ORDINANCE OF THE COMMON COUNCIL			
Approving a Planned Development - General Development Plan for Lots 1, 3 and 4 within 51 West Development			
Committee Action:	Plan Commission recommends Council approval 6 - 0 No action at Public works-lack of quorum		
Fiscal Impact:	Increased Tax Base and Park Impact Fees		
File Number:	O - 26 - 2022	**Date Introduced:** **Re-Introduced:**	October 25, 2022 November 15, 2022

Planned Development General Development Plan for 51 West Development, Lots 1, 3 and 4.

GENERAL DEVELOPMENT PLAN

Lots 1, 3 and 4 at 51 West
Stoughton, WI

OVERALL UTILITY PLAN

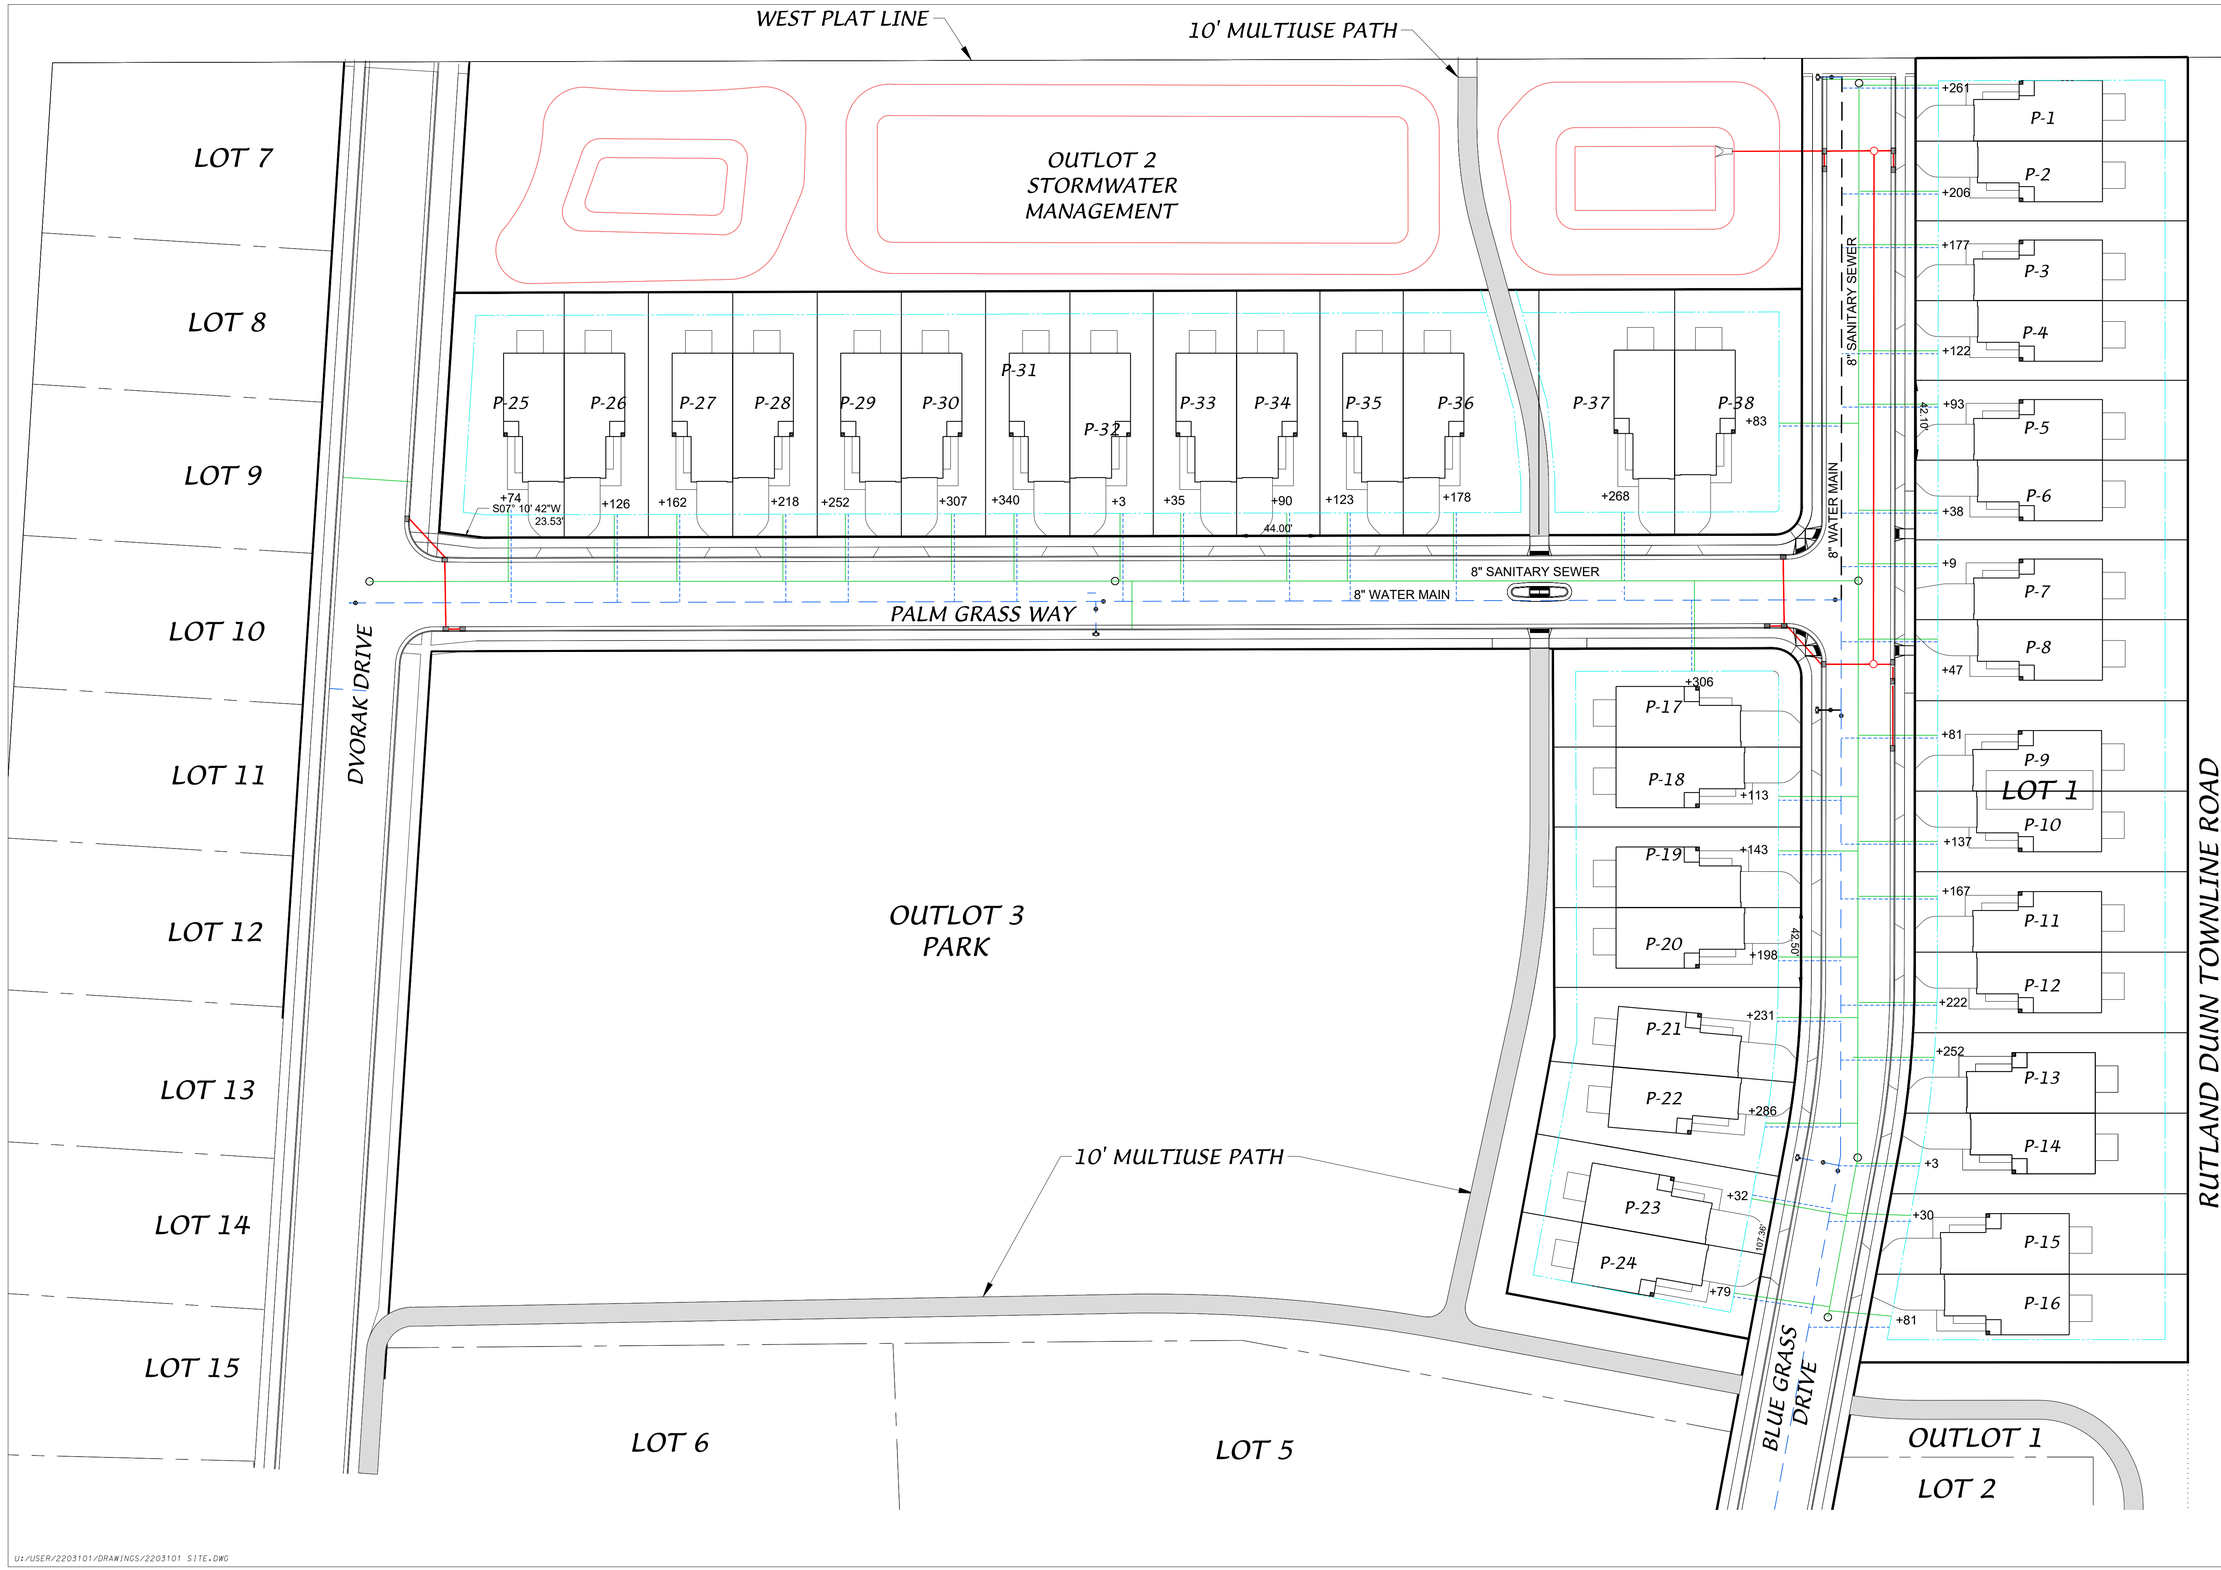
2. A utility plan is necessary showing locations for hydrants, water, electric and sewer services. Stoughton Utilities will need to determine if the size of water and sewer mains will accommodate the increase in density. **Provided**

LANDSCAPE PLAN

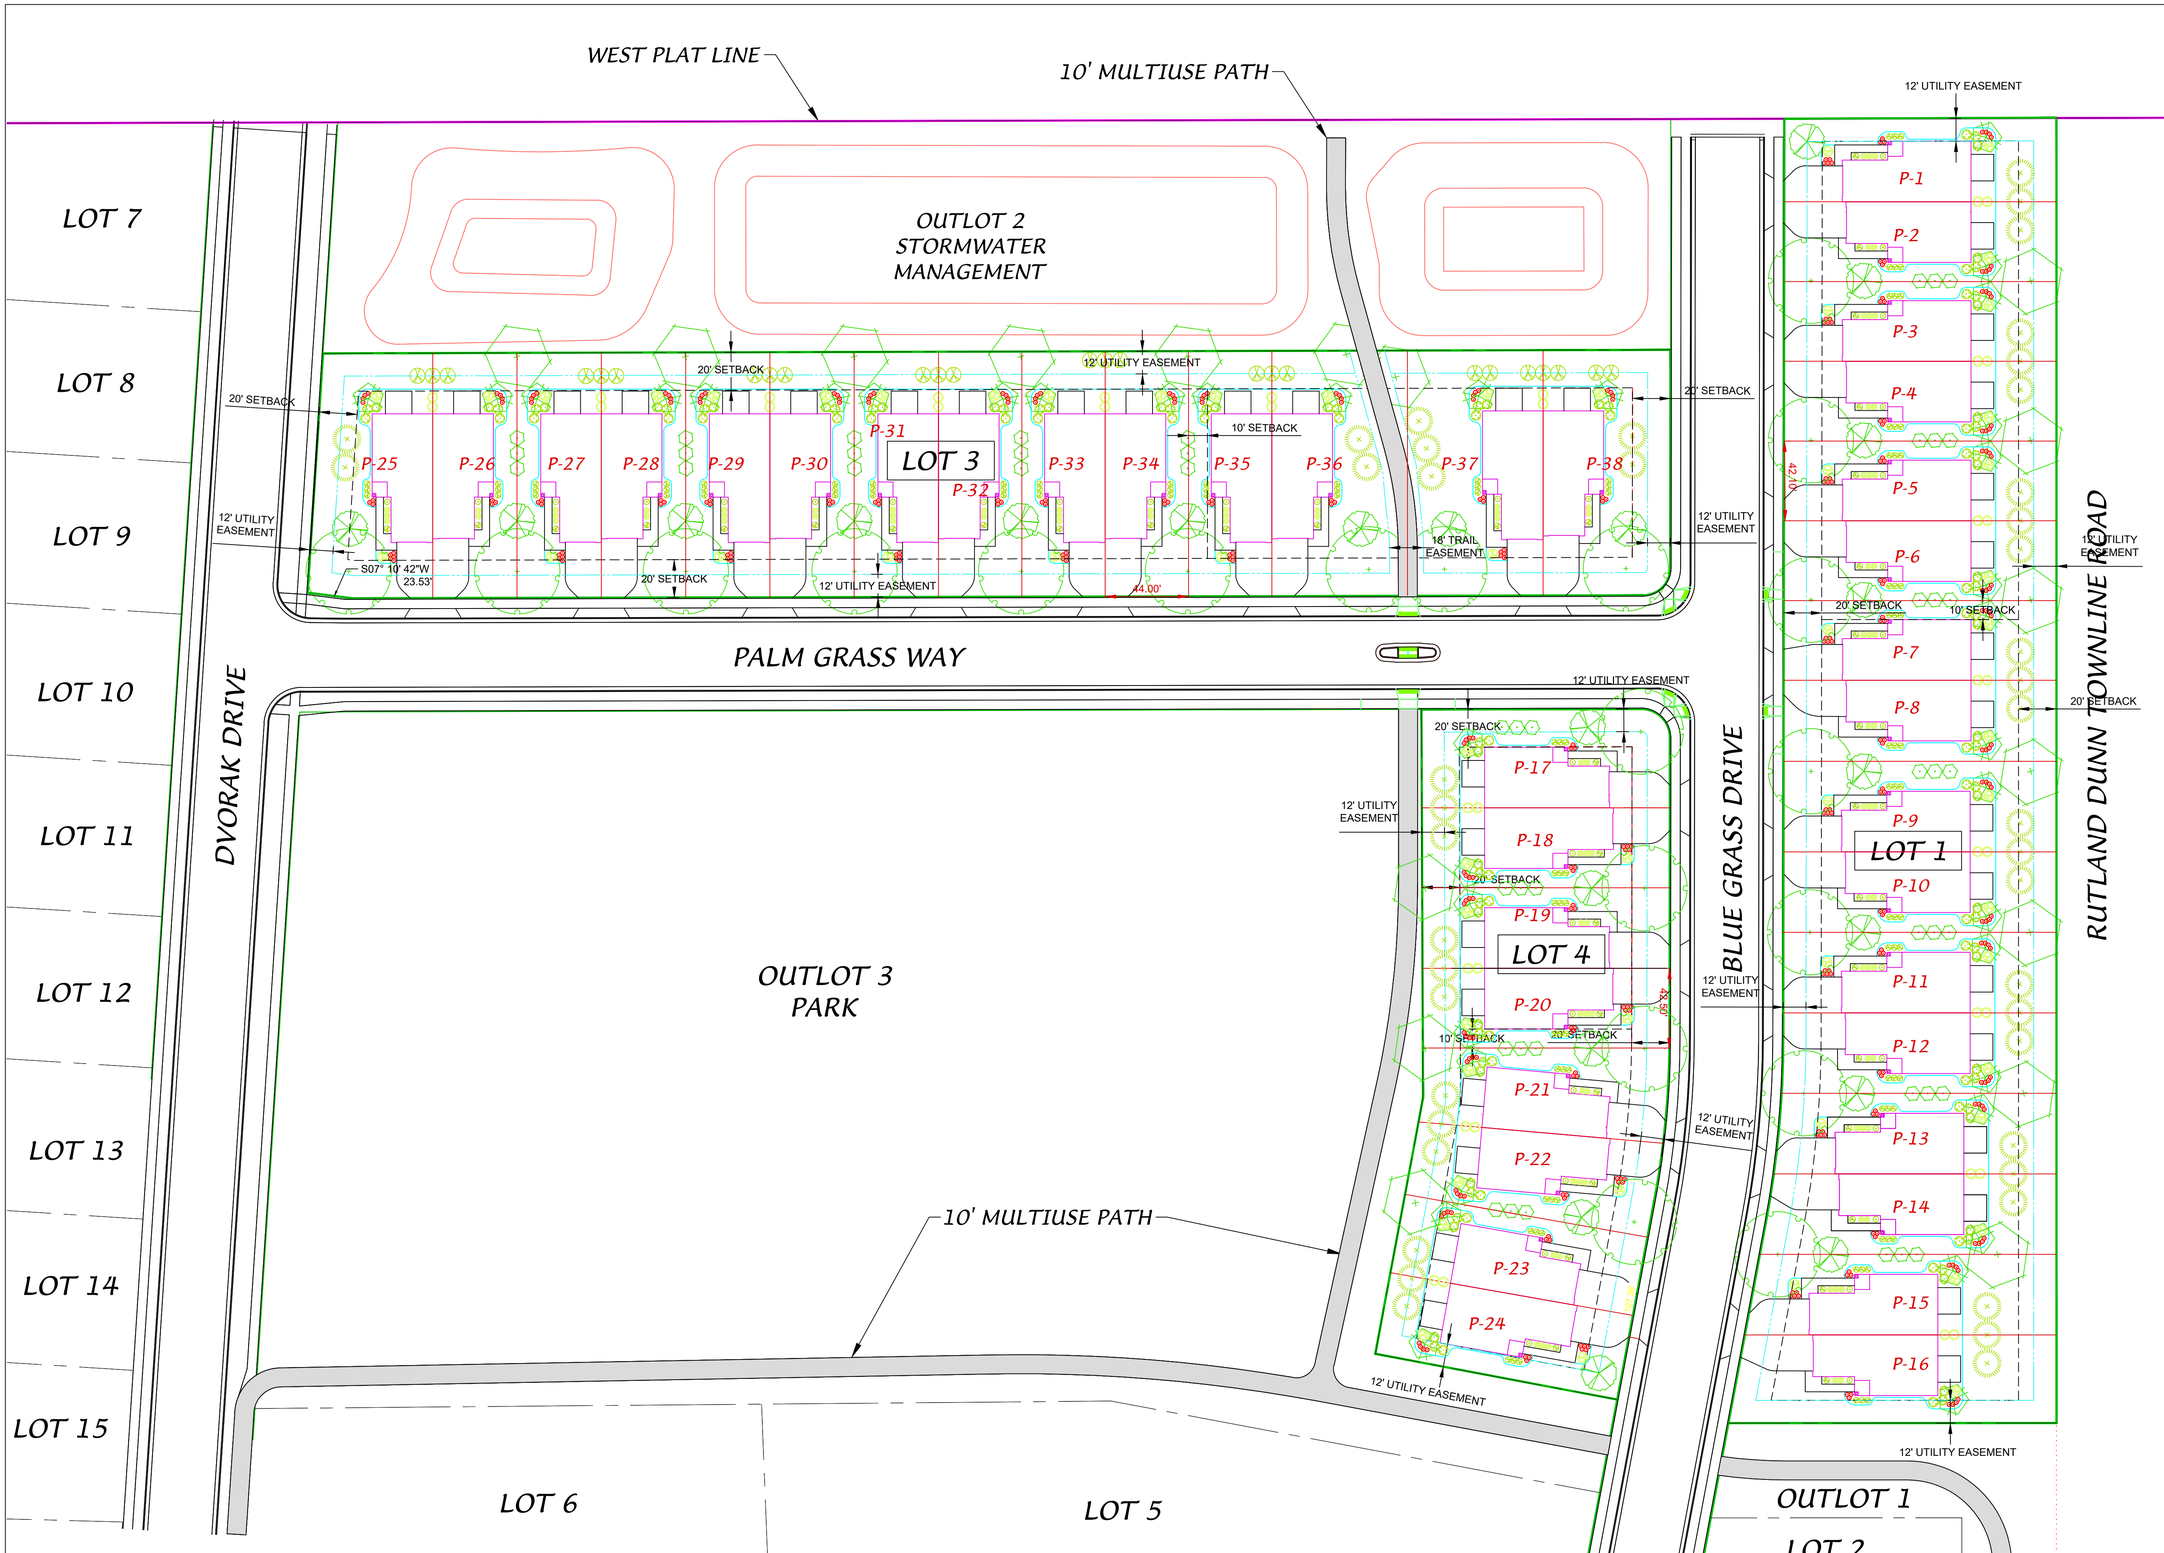
E. A general conceptual landscaping plan for subject property, noting approximate locations of foundation, street, yard, paving and landscaping. **Provided – <u>A more detailed plan will be necessary at the SIP stage. Vision triangles at intersections and driveways will need to meet code.</u>**
